**TRANSMITTAL OF DESIGN CHANGE NOTICES FOR THE HAUL ROAD/RELOCATED NORTH ENTRANCE ROAD PROJECT, THE LEACHATE CONVEYANCE SYSTEM PROJECT, AND THE ON-SITE DISPOSAL FACILITY PROJECT**

**Design Change Notice (DCN) Report for On-Site Disposal Facility (OSDF) - Phase I  
Subcontract No. FY 597**

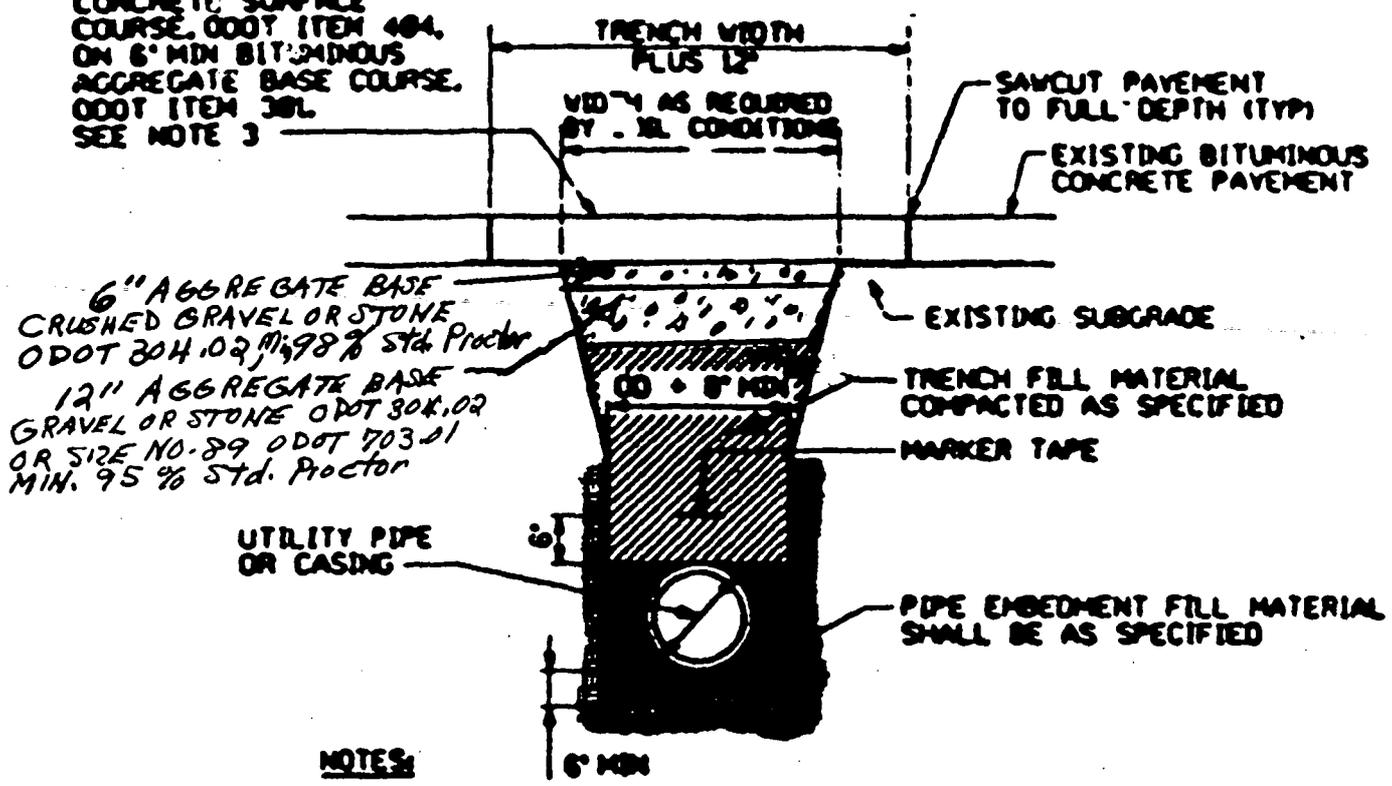
This DCN adds to the existing Pavement Restoration Detail on Drawing 92X-5900-G-00257 Rev.0 granular subbase requirements. These requirements are consistent with pavement restoration repairs used at this site. The modification to the restoration detail is attached and is summarized as follows:

PCN 1700-025  
SHT. 2 OF 3

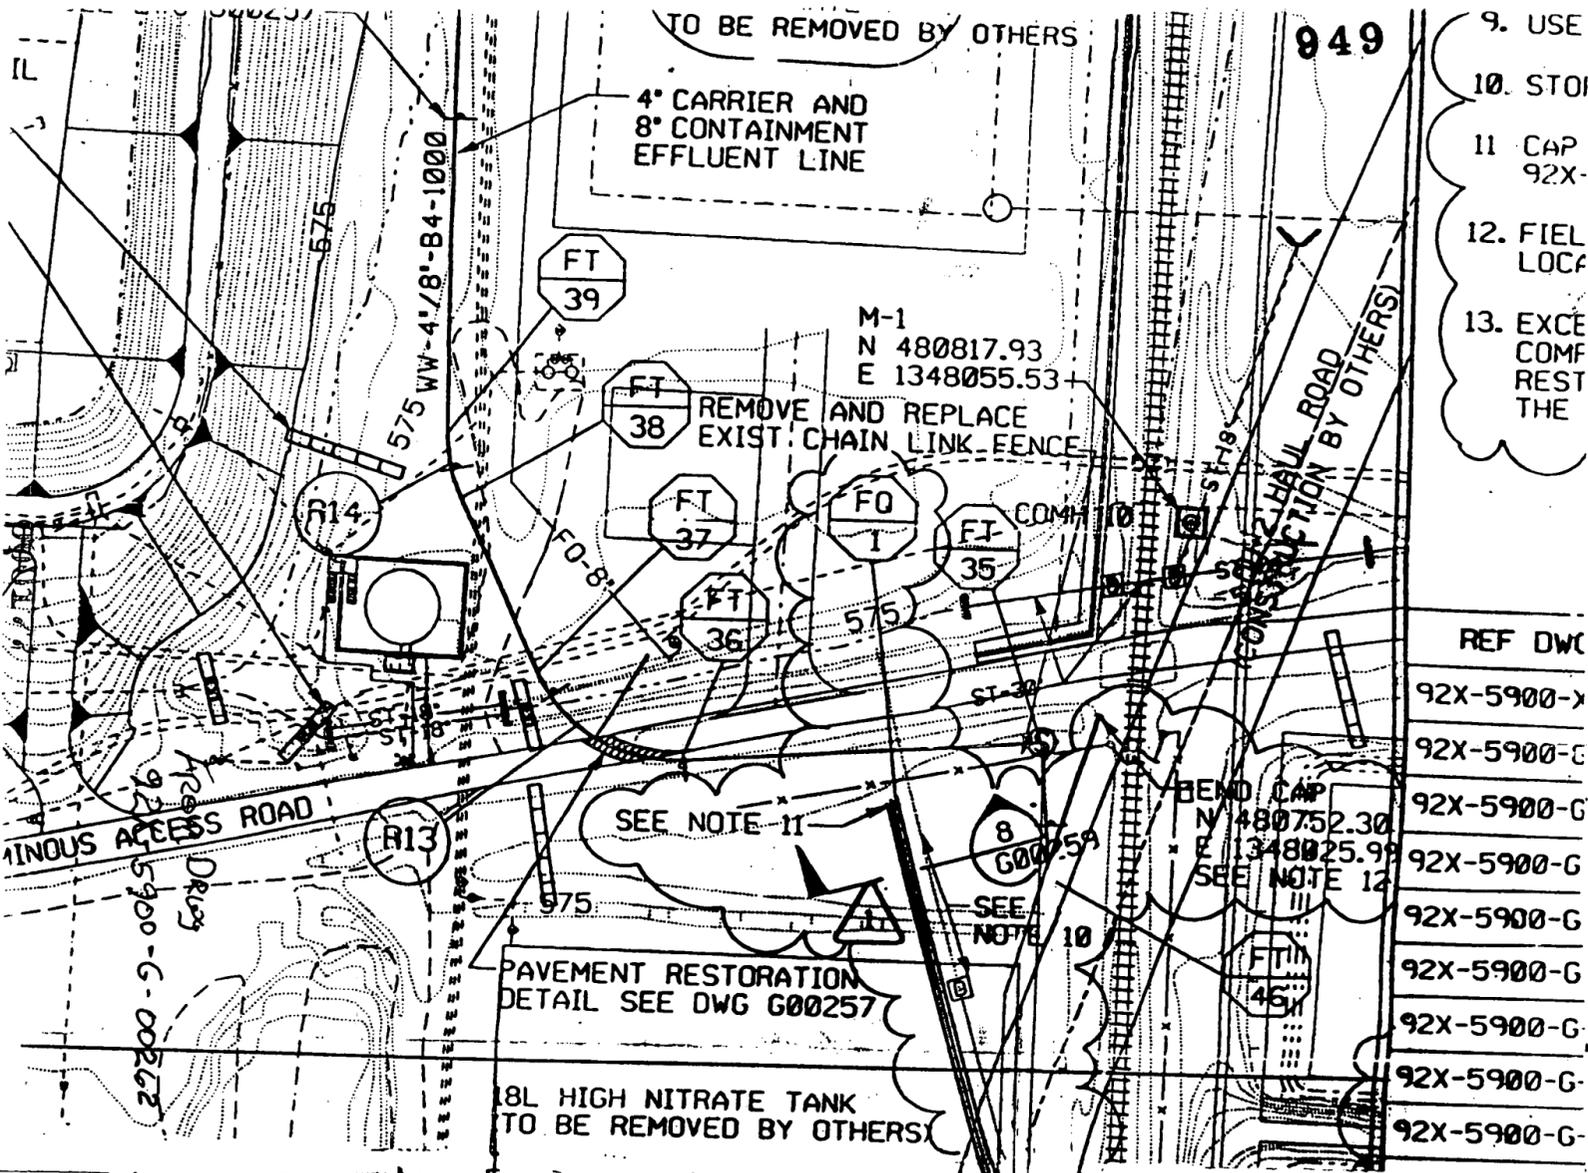
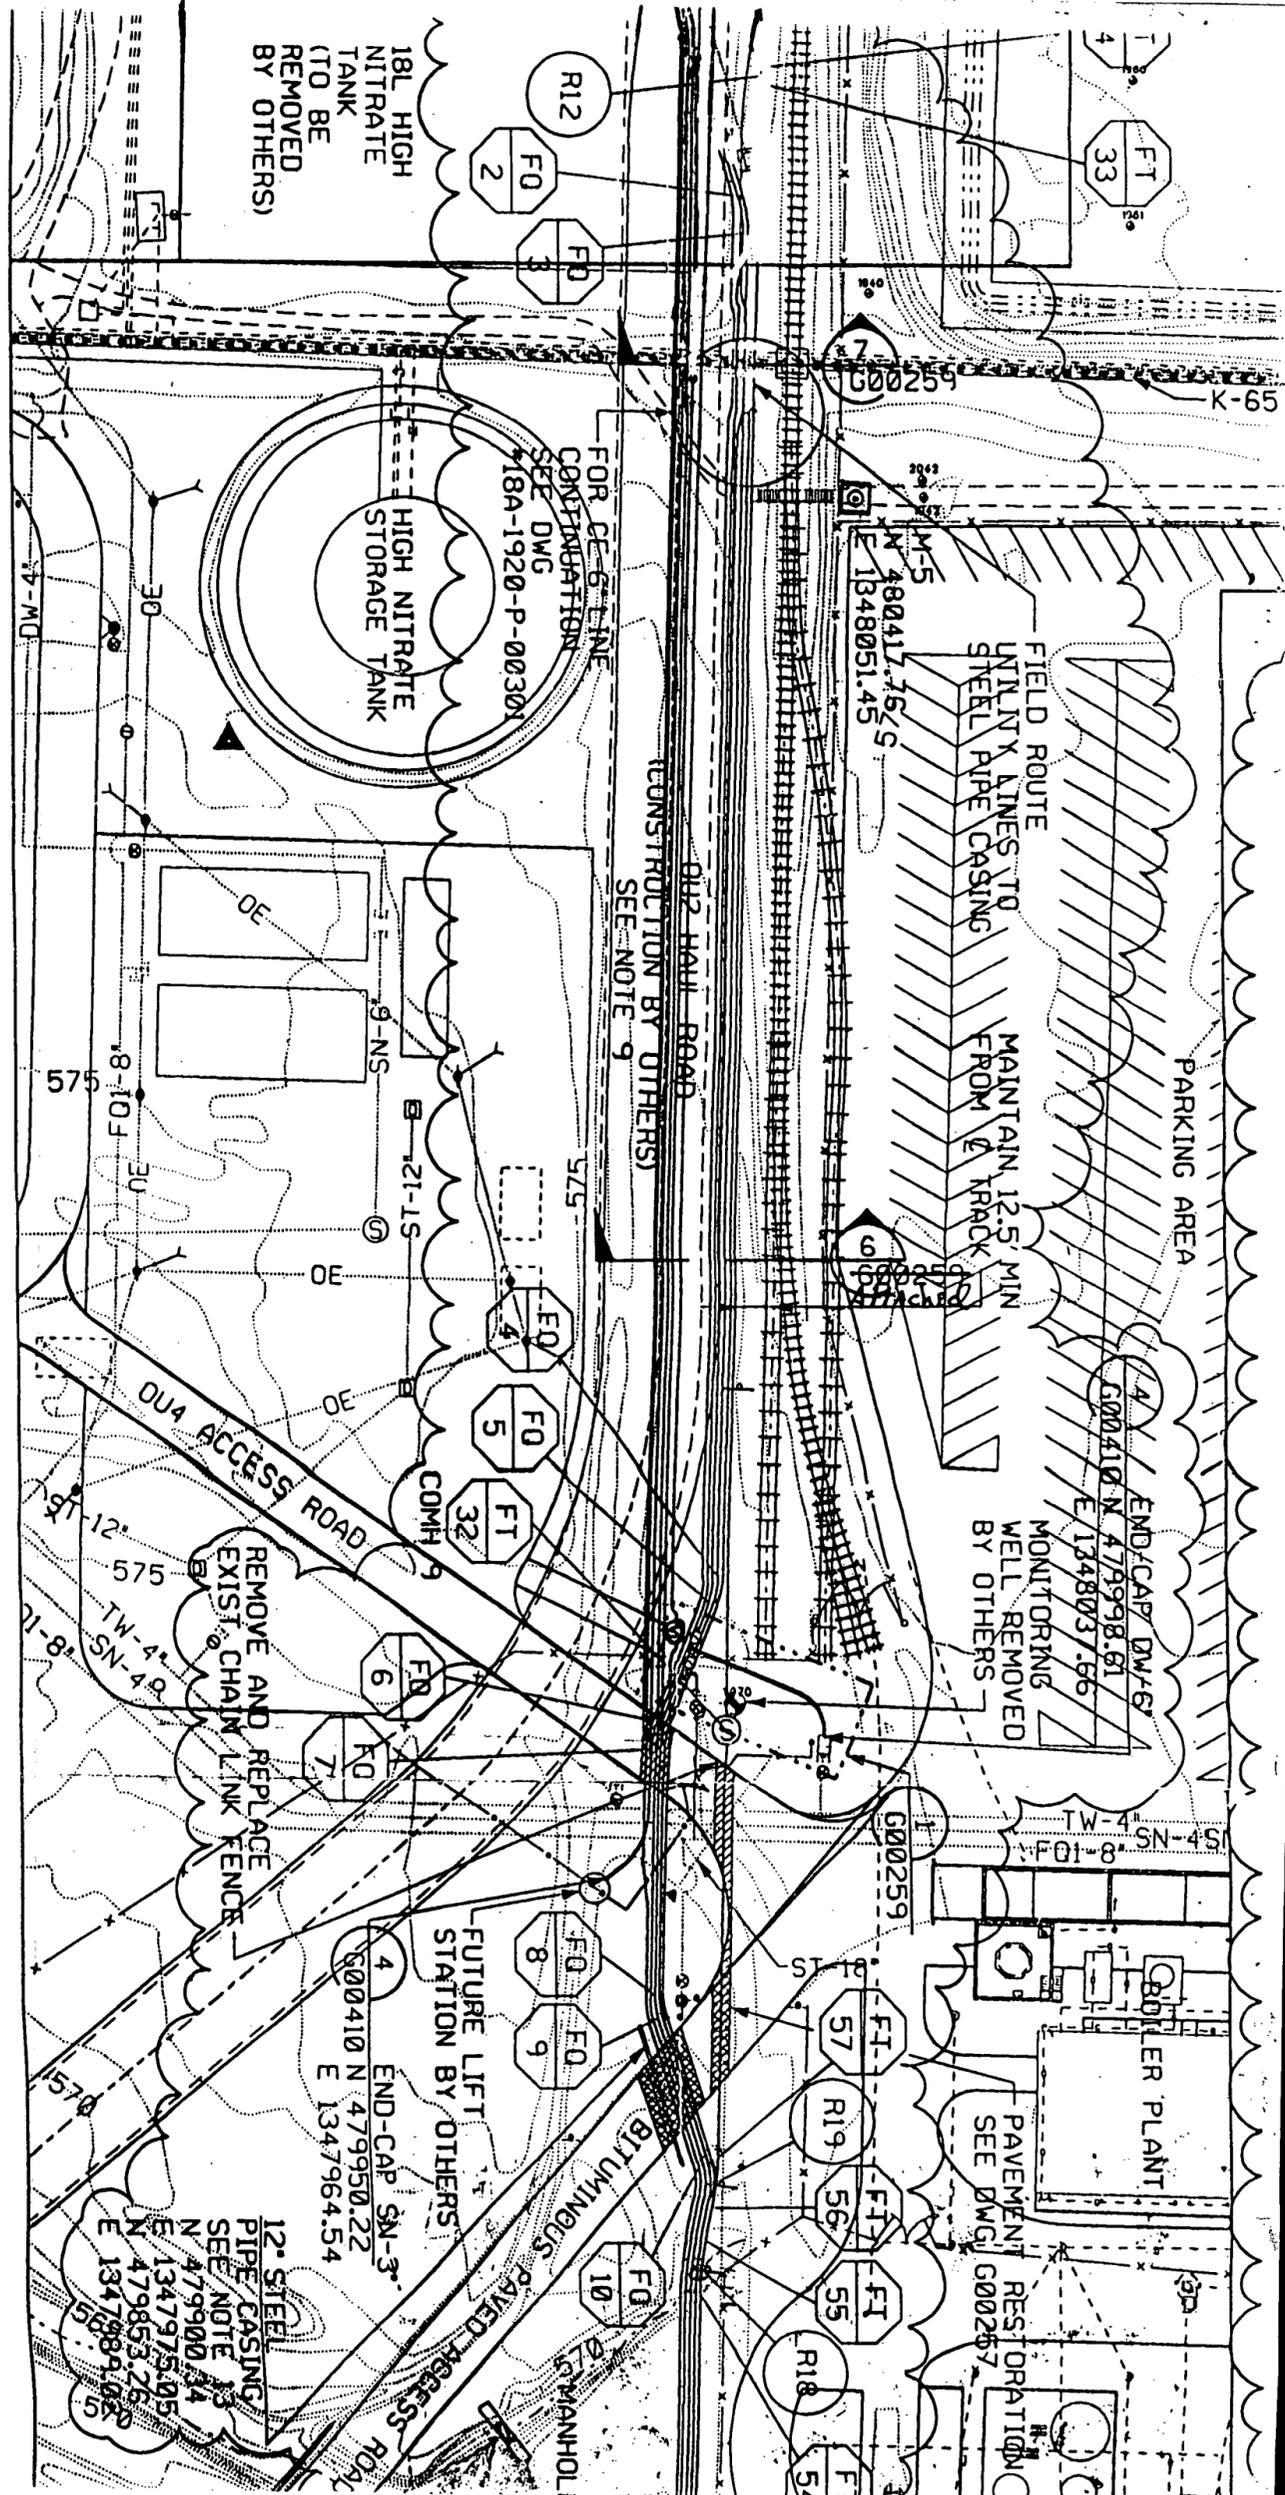
- A. The PIV's and laterals shown on Dwg G00266 and on Detail 1, Dwg G00259 were not shown to be installed on Sketch #20110-SK-009. The PIV's and COMH 9 should be installed as far as possible away from the proposed edge of pavement while holding the designed tie-in locations.
- B. Since the utility corridor is being relocated underneath the proposed OU2 haul road, it is especially important that the materials, installation, and compaction of the pipe embedment and trench fill are provided in accordance with the construction specifications.

D. It is recommended that this DCN receive status "B" approval.

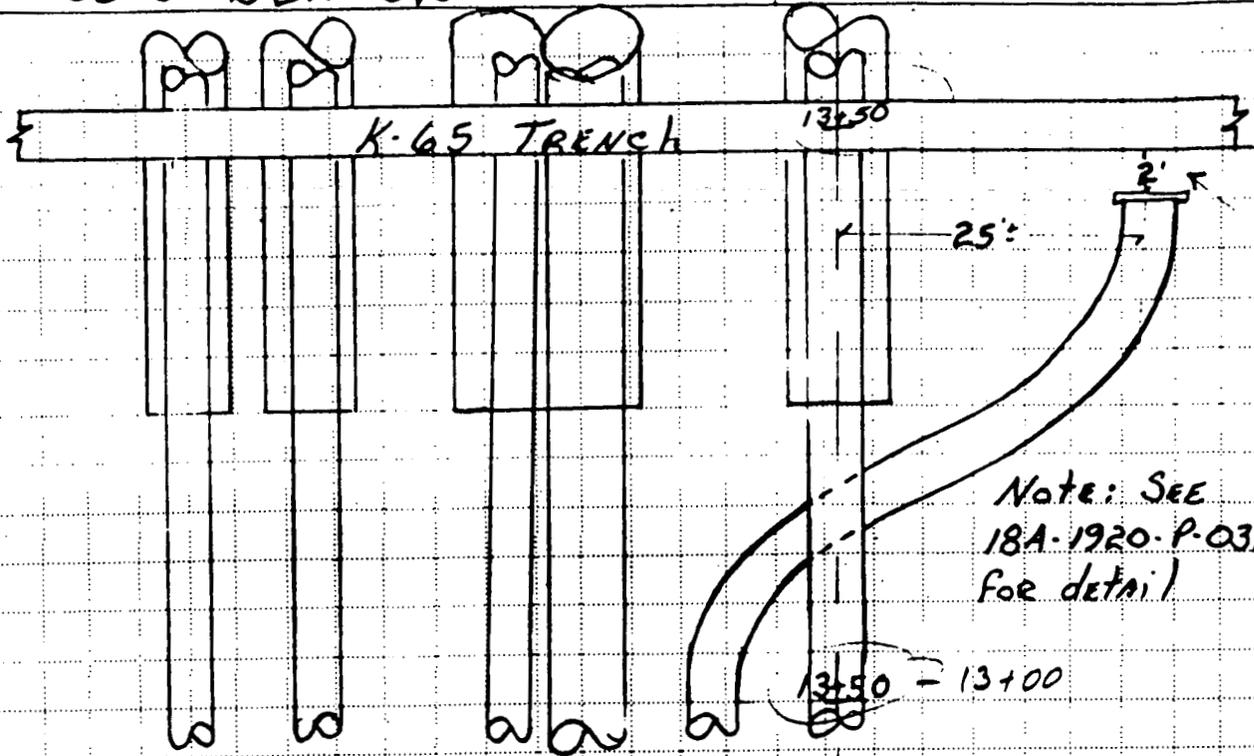
1. An earlier DCN (1700-025) had a sketch, 20110-SK-008, which showed the proposed centerline to centerline, c/c, distance from Rail to 4"/8" LCS line to be 30'±. The c/c distance proposed for CE-6" stub out to 4"/8" LCS to be 25'±. This will place the stub out very close to the rail ballast/ties and the concrete support for the rail crossing of the K-65 trench. Recommend that the 25' be modified to 12'-15'. Also that the bending of the CE-6" line start 10' from the flange versus at the flange and the deflection angles of the line approximate 45°. See enlargement from 92X-5900-G-00266 (modified).

2. The original design of the common trench indicated a common trench bottom in this area except for the FG-6" line (Section 6, 92X-5900-G-00259). Sketch 20110-SK-011 shows the 4"/8" LCS line to be higher than the other lines. Recommend that the original profile be maintained except for the CE-6" line which can be routed lower (like the FG-6") and under the 4"/8" LCS line. This will require a lot less cut. Maintain minimum cover and clearance as indicated on the construction drawings.

3. The tie in to the K-65 trench detailed on drawing 18A-1920-00301, Rev 2 was not evaluated as it was beyond the original scope of work.

Civil approves as noted below.

**Civil Comments**

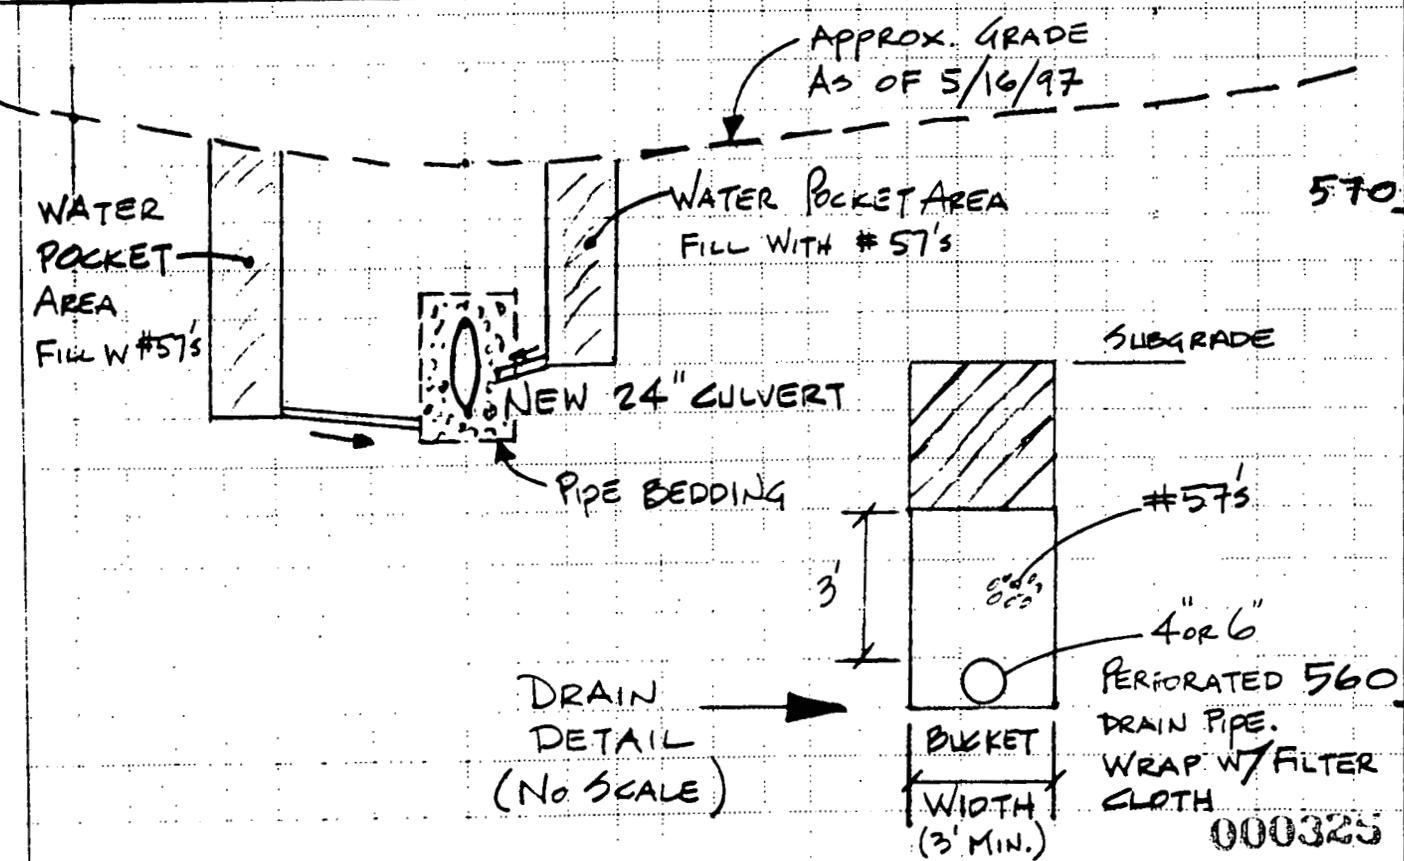
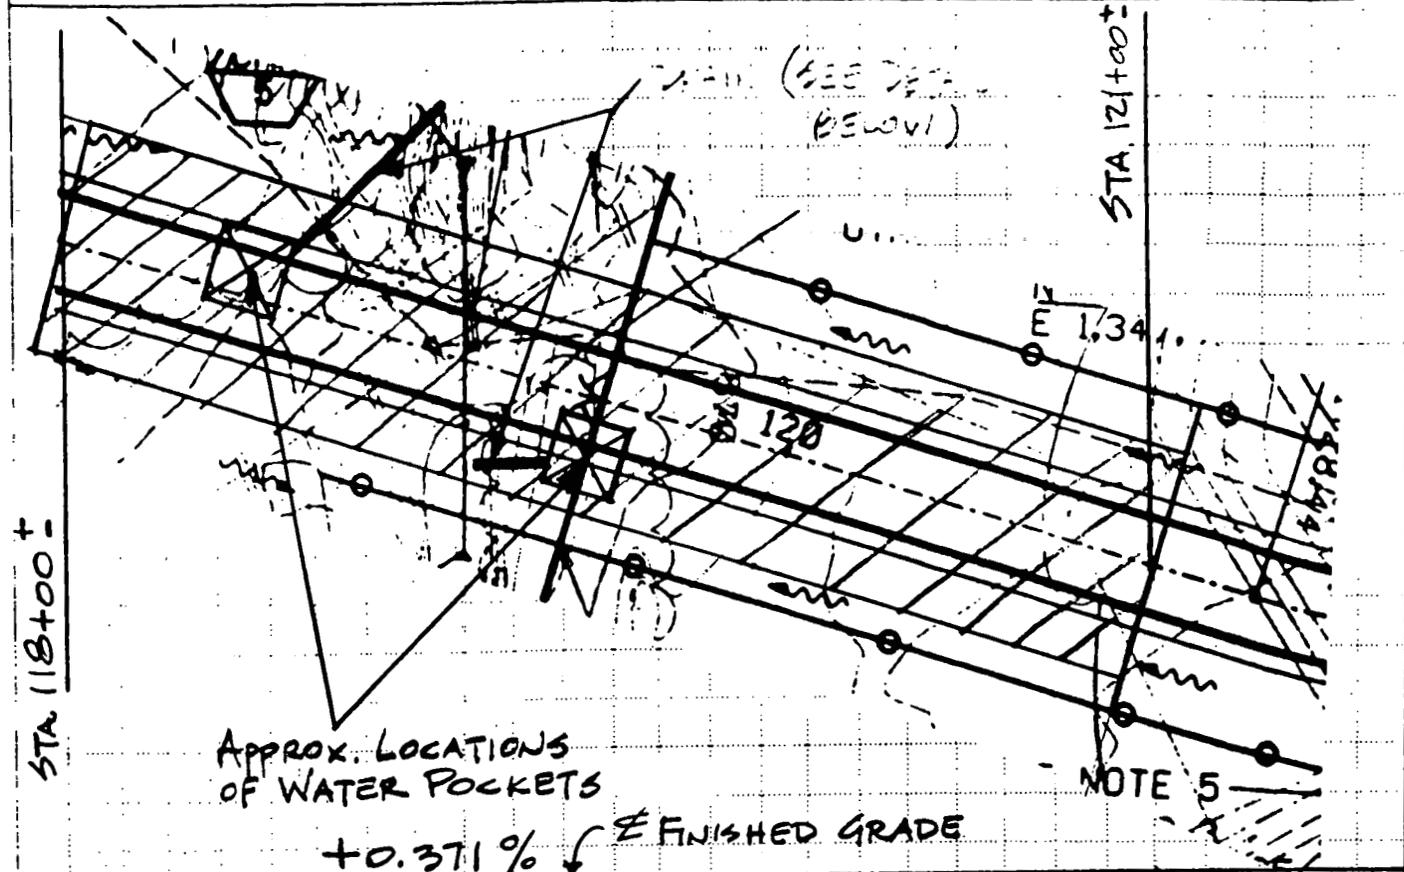
.....direct Barrett Paving to excavate structurally unsuitable soil to an elevation of 570' with side slopes of 1.5 to 1.0 beginning approximately at station 122+30 (N 480051.58). The floor of the excavation extending 12' to the left and the shoulder of the slope 45 feet to the right. The excavation continues to Station 126+00.00 (K-65 trench) 12 feet to the left and the shoulder of the right slope nearly as practicable to the railroad siding without undermining the railroad roadbed.

1. Underdrains shall be installed according to ODOT Item 605.
2. Pipe to be 6-inch in diameter, perforated, and may be one of the following materials:
